President and Board of Trustees
Village of Arlington Heights
Board Room

- A. St. James Parish - 831 N. Arlington Heights Rd. - PC#17-012
Planned Unit Development, Amendment to Special use
Ordinances #63-078, #97-078, #07-012, Amendment to the
Comprehensive Plan, Plat of Subdivision, Variations

To: Charles Perkins-Witherington, Director of Planning and Community Development
From: Sam Hubbard, Development Planner
Date: 1/10/2018
Re: PC #17-012: St. James Parish

PROJECT NAME:
VILLAGE SUBMITTAL
CHURCH ADDITION
AND RENOVATION
831 N. ARLINGTON HEIGHTS ROAD
ARLINGTON HEIGHTS, ILLINOIS 60004

SIGNAL EXHIBIT
(OPTION 1)

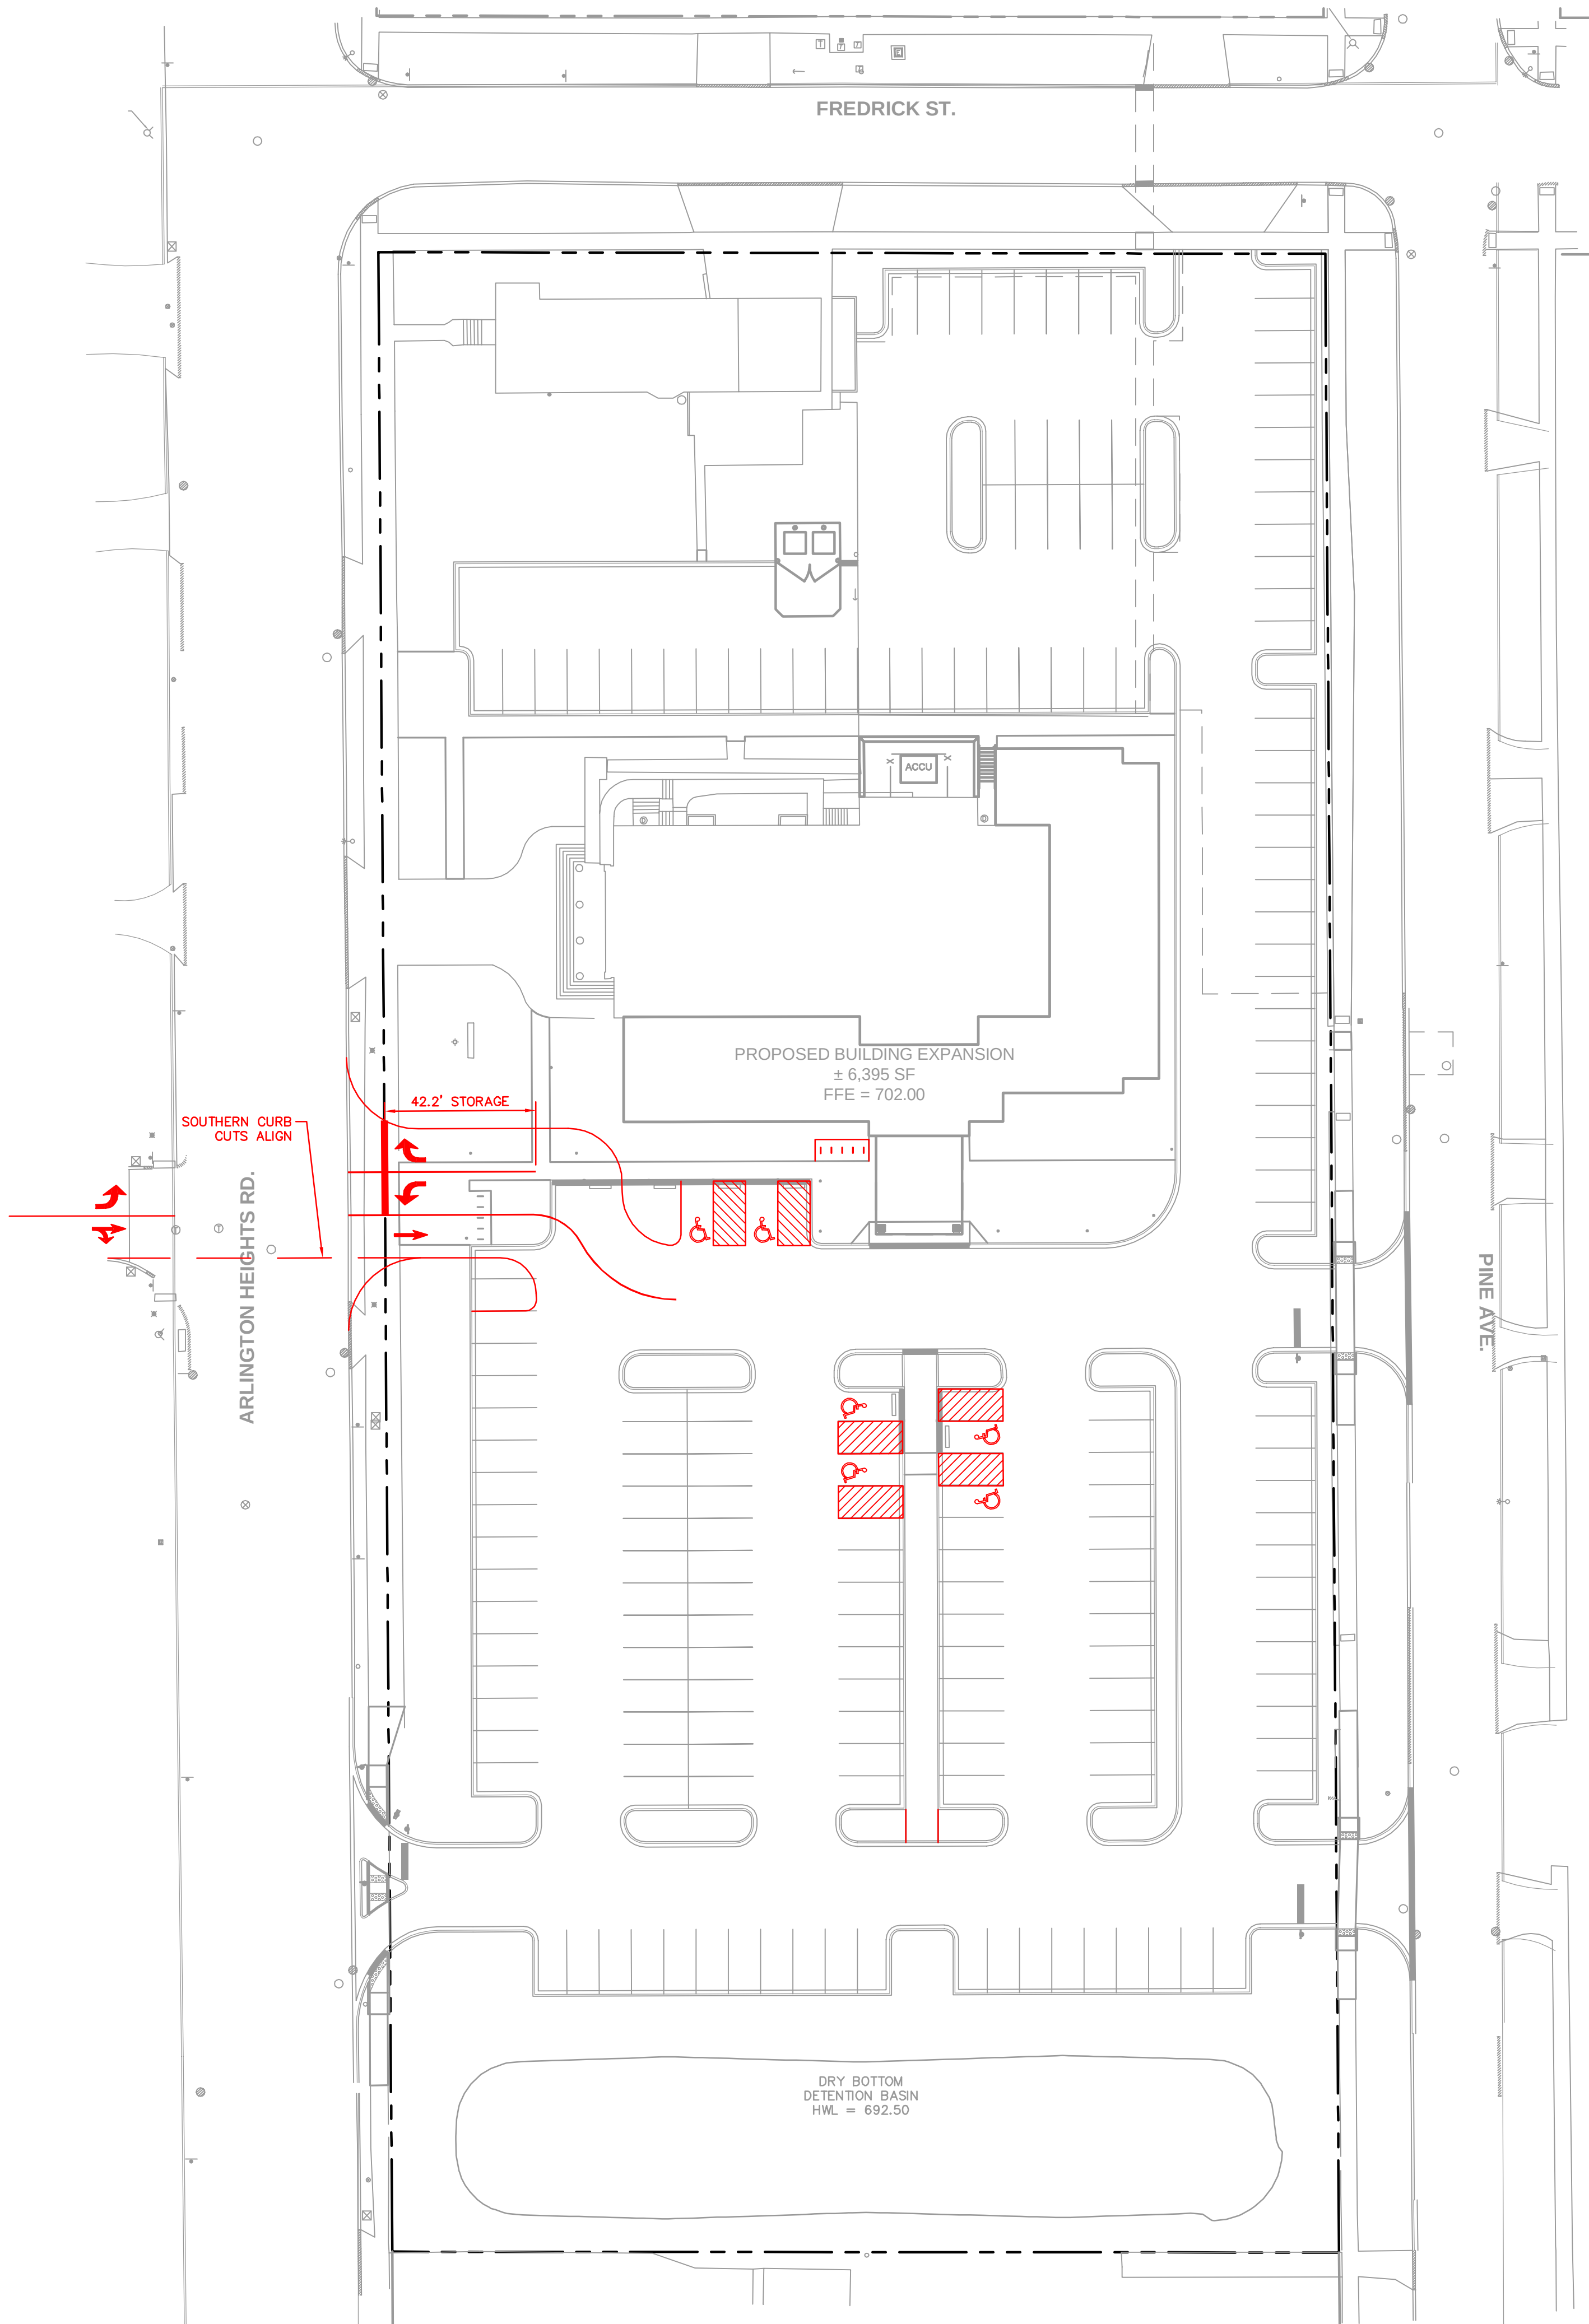
1. The Petitioner shall provide a written narrative of the various design options that were considered relative to aligning the ingress/egress to and from the site with the existing traffic signal on Arlington Heights Road, and the reasons for not pursuing those options. This narrative must include details on the geometric, traffic operation, and traffic signal considerations relative to this alignment. Upon receipt of this information, the Village, the Petitioner, and IDOT shall meet to discuss the proposed access on Arlington Heights Road.

1. The petitioner shall provide a written narrative of the various design options that were considered relative to aligning the ingress/egress to and from the site with the existing traffic signal on Arlington Heights Road, and the reasons for not pursuing those options. This narrative must include details on the geometric, traffic operation, and traffic signal considerations relative to this alignment. Upon receipt of this information, the Village, the petitioner, and IDOT shall meet to discuss the proposed access on Arlington Heights Road.

On December 20, 2017, the petitioner provided a formal response to staffs request to analyze the feasibility of aligning their ingress/egress to Arlington Heights Road with the existing traffic signal that serves the St. James Parish school on the west campus. Two alternatives were provided that showed an ingress/egress drive aligning with the existing traffic, as well as an accompanying analysis of the cost and pro's and con's of these alternatives. The two alternatives provided by the petitioner do not represent all possible options, for example, an exit only option has not yet been explored.

On December 29, 2017, the Village provided a response to these alternatives and requested that the petitioner coordinate a meeting with IDOT and the Village to discuss the feasibility of the driveway alignment with the existing traffic signal.

ACCESS DETAIL
1"=10'

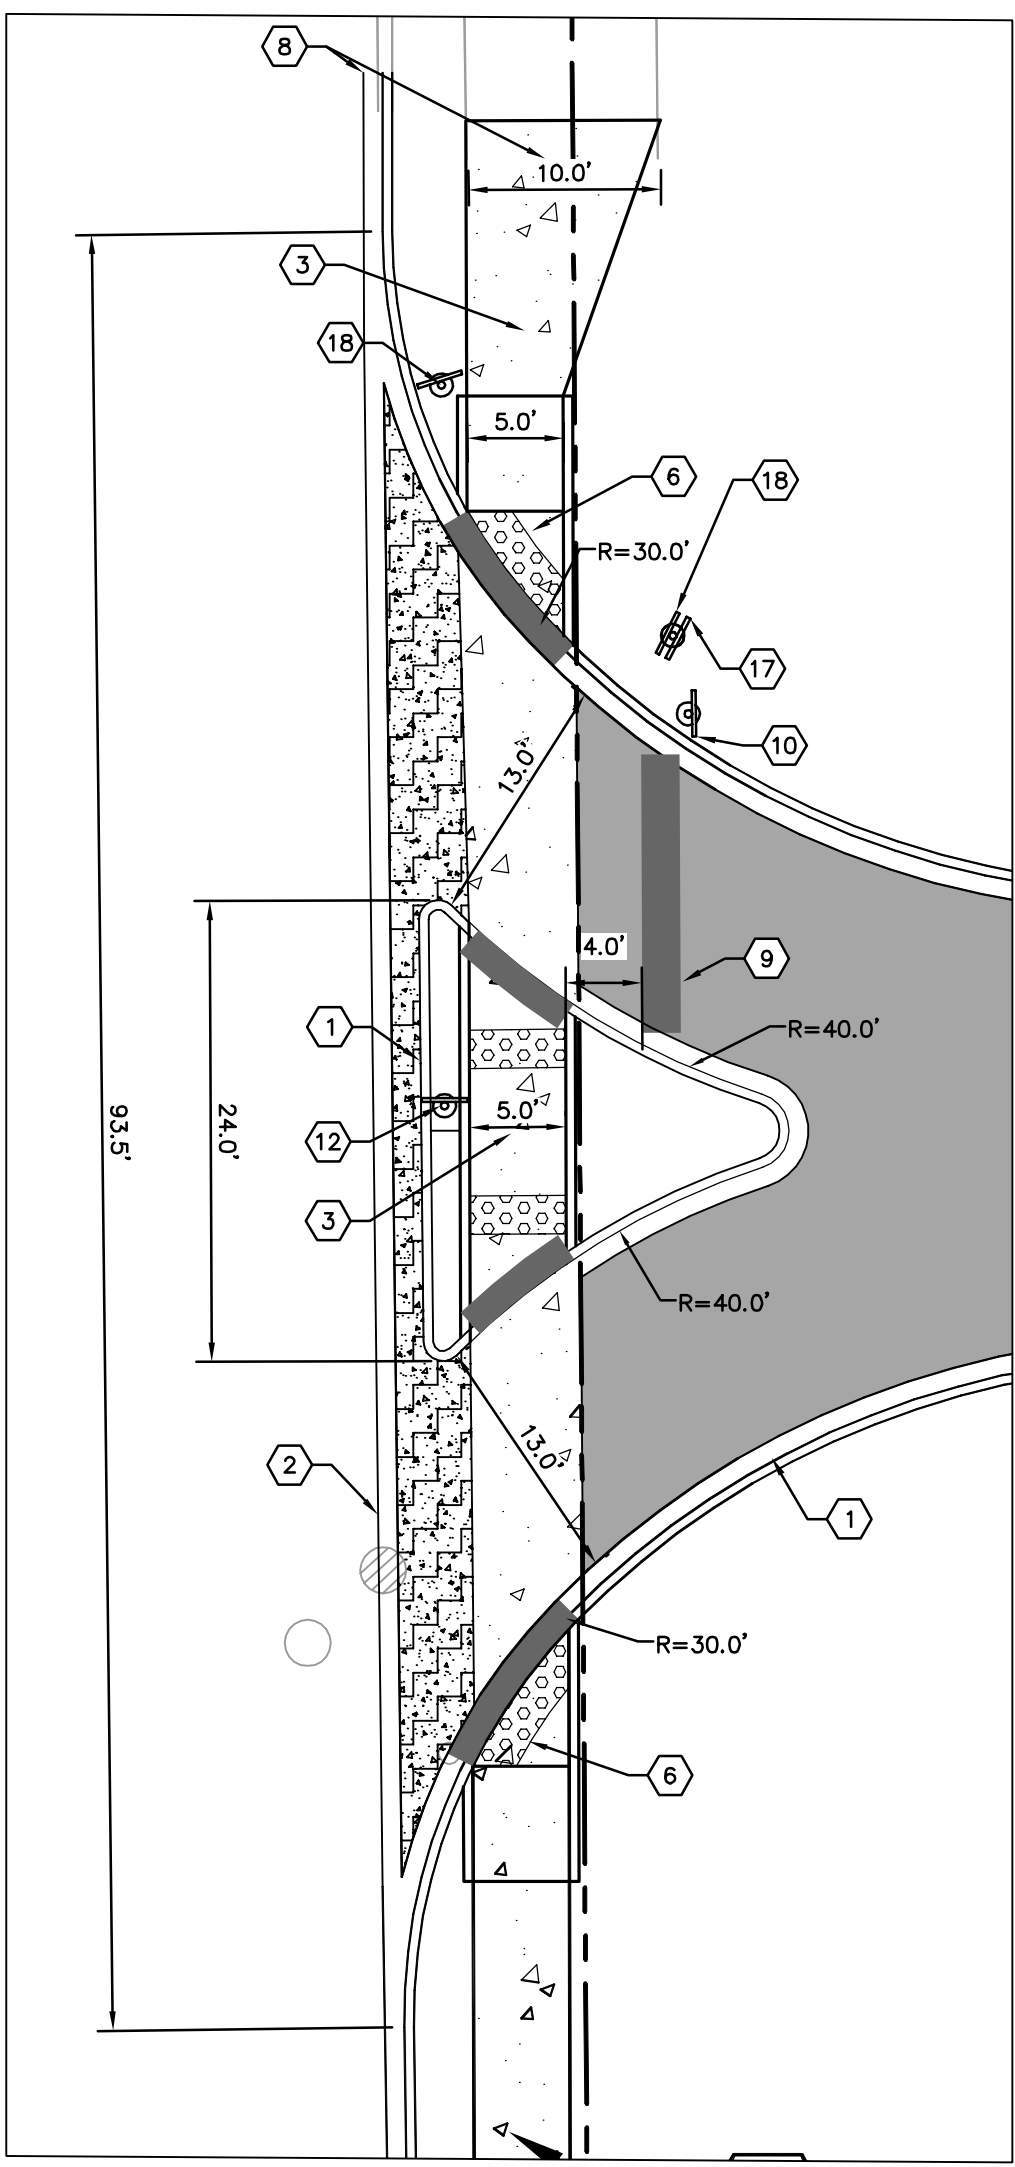
64. Comment #54 was not directly responded to. To reiterate: Sheet C3.0: At the RIRO driveway on Arlington Heights Road, the public sidewalk shall take precedence over the curb and shall be continuous through the driveway with the curbs stopping on either side of the sidewalk. This comment can be addressed at final engineering.

65. Comment #55 was not directly responded to. To reiterate: Sheet C3.0: All utility open cuts on Village streets will require heavy duty pavement as replacement. This comment can be addressed at final engineering.
66. Comment #56 was not directly responded to. To reiterate: Sheet C3.0: It is suggested additional private driveway and public sidewalk removal and replacement be shown on the north side of Frederick Street to account for the impact associated with the installation of the 5' diameter valve vault. This comment can be addressed at final engineering.
67. Comment #57 was not directly responded to. To reiterate: Sheet C7.0: The pavement thicknesses for the heavy duty pavement section must conform to the following: 2" Surface, 2-1/4" N-50 Binder, 5" N-30 Binder, and 4" CA-6 Stone Subbase. This comment can be addressed at final engineering.

54. Sheet C3.0: At the RIRO driveway on Arlington Heights Road, the public sidewalk shall take precedence over the curb and shall be continuous through the driveway with the curbs stopping on either side of the sidewalk. This comment can be addressed at final engineering.

55. Sheet C3.0: All utility open cuts on Village streets will require heavy duty pavement as replacement. This comment can be addressed at final engineering.

56. Sheet C3.0: It is suggested additional private driveway and public sidewalk removal and replacement be shown on the north side of Frederick Street to account for the impact associated with the installation of the 5' diameter valve vault. This comment can be addressed at final engineering.

Response: The plans have been revised to show the public sidewalk sections being carried through the driveways. Curbs will not be constructed through the public sidewalks. ADA panels will be installed at all drives with stop control. See Sheet C3.0.

Response: Depressed curb and gutters have been added along the Pine Street drives. The curb returns have been reduced to 15'. See Sheet C3.0.

Response: All sidewalks adjacent to parking stalls have been widened to 6.5' width. This allows a 5' wide sidewalk width if a parked car has a 1.5' overhang. See sheet C3.0.

UTILITY PLAN

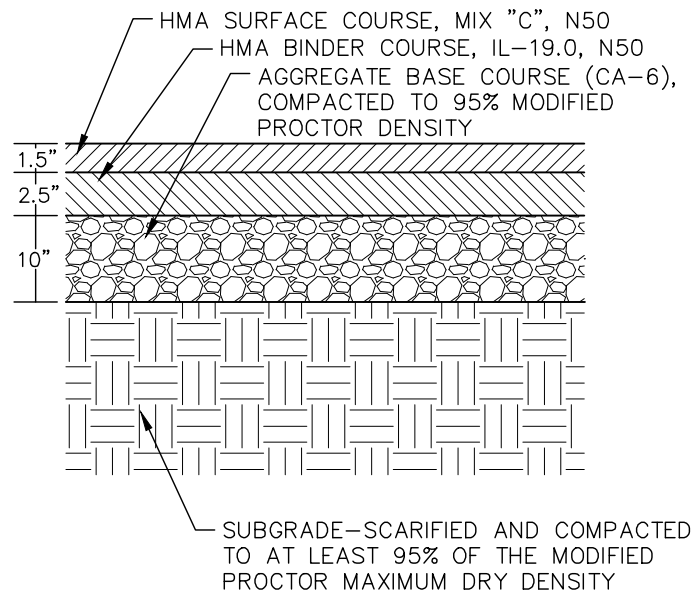
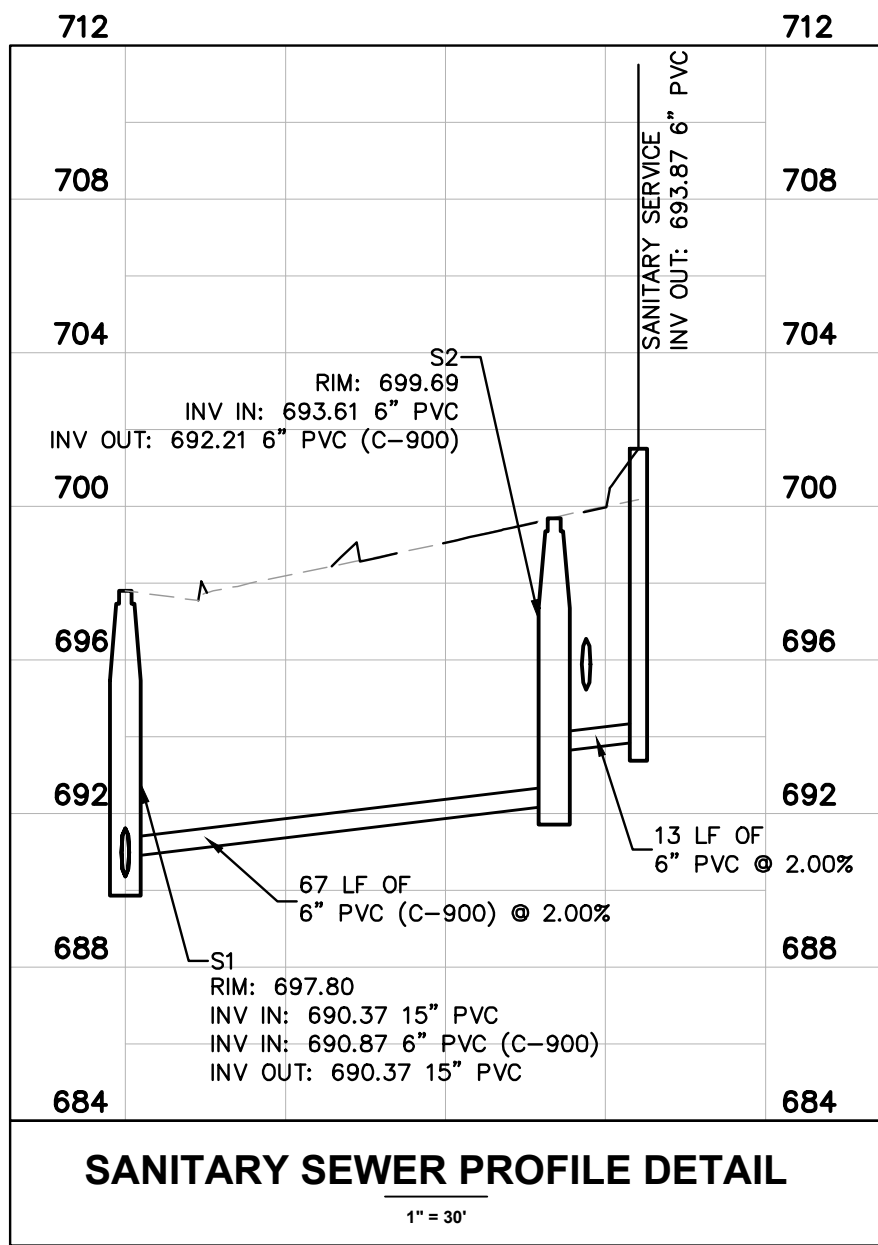
1. The fire hydrant must be an East Jordan 5BR250 and must conform to Village standards. Adjust the hydrant detail on page C7.1.
2. The revised hydrant location must be reflected within the public ROW on page C 6.0. Adjust the location on page C 6.0.
3. A 6" compound water meter will be required for this application.
4. An RPZ will be required for protection of the fire and the domestic service. Sizes will be provided when plumbing plans have been submitted.

1. Contact and coordinate the relocations of both hydrants with the Public Works Distribution Unit at 847-368-5800.
Response: A note has been added to Drawing C6.0 to contact Public Works for hydrant relocation.
2. If a private hydrant is going to be installed (W2), a master meter vault with meter must be installed after (W1).
Response: After discussion with Public Works, the fire hydrant will be relocated to the Pine Avenue Right of Way. It was noted that Public Works would maintain this hydrant. This has been revised on Drawing C6.0.

**HEAVY DUTY
ASPHALTIC PAVEMENT SECTION**
N.T.S.

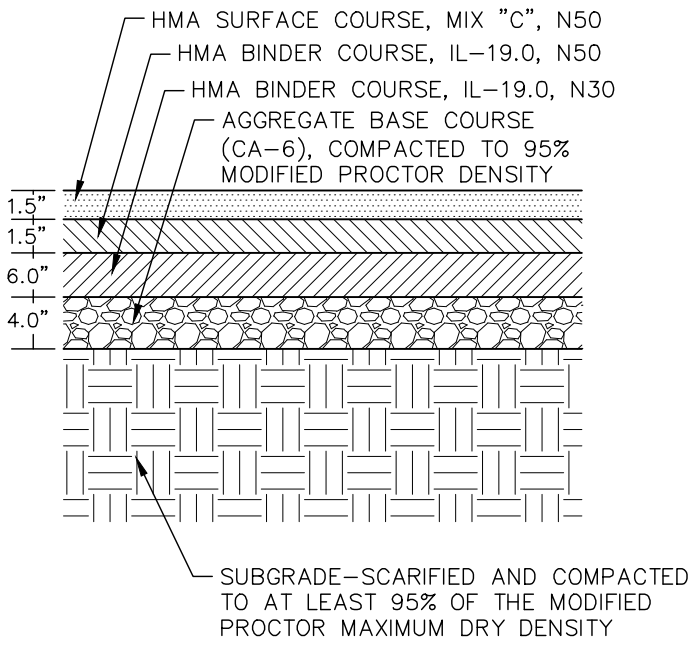
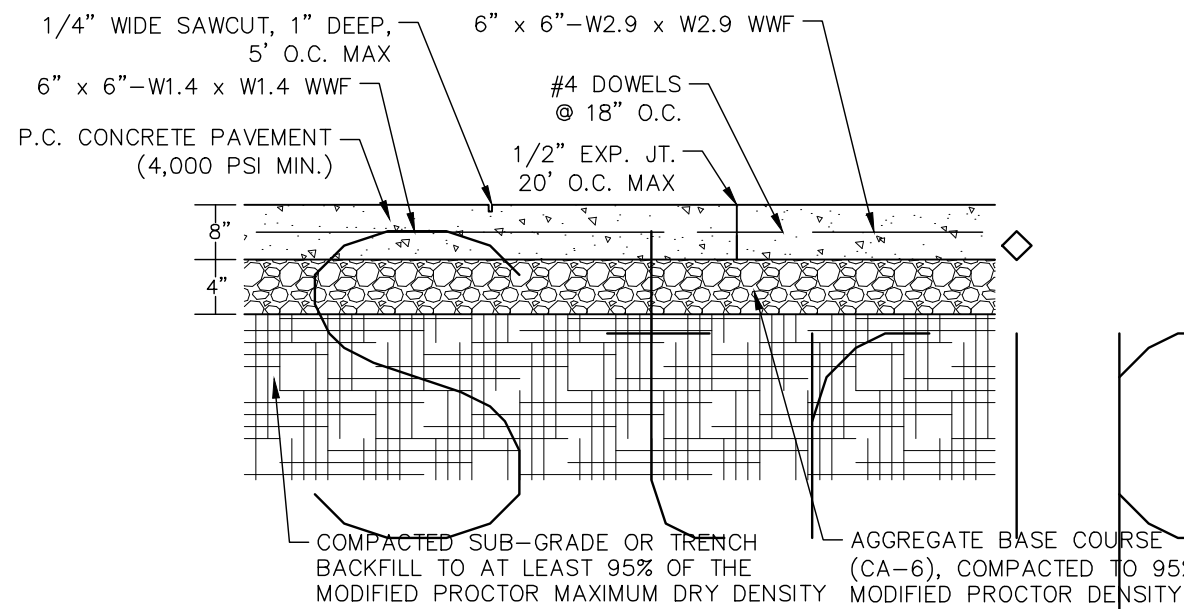
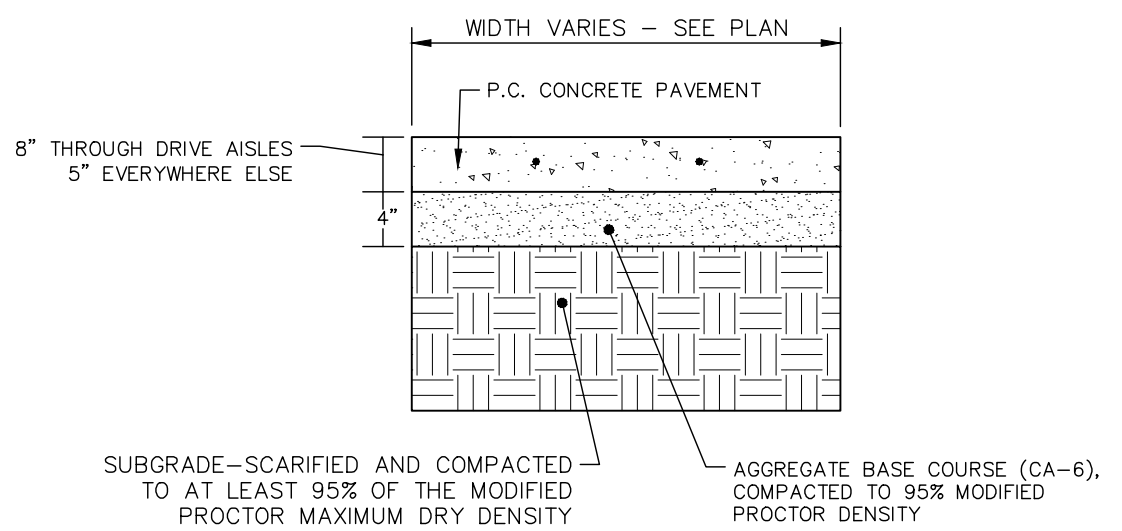
57. Sheet C7.0: The pavement thicknesses for the heavy duty pavement section must conform to the following: 2" Surface, 2-1/4" N-50 Binder, 5" N-30 Binder, and 4" CA-6 Stone Subbase. This comment can be addressed at final engineering.

Response: The heavy duty asphalt pavement section has been revised to meet the required materials and thicknesses. The concrete sidewalk detail has been revised to specify an 8" thickness in the driveway aprons and public sidewalks. See Sheet 7.0.
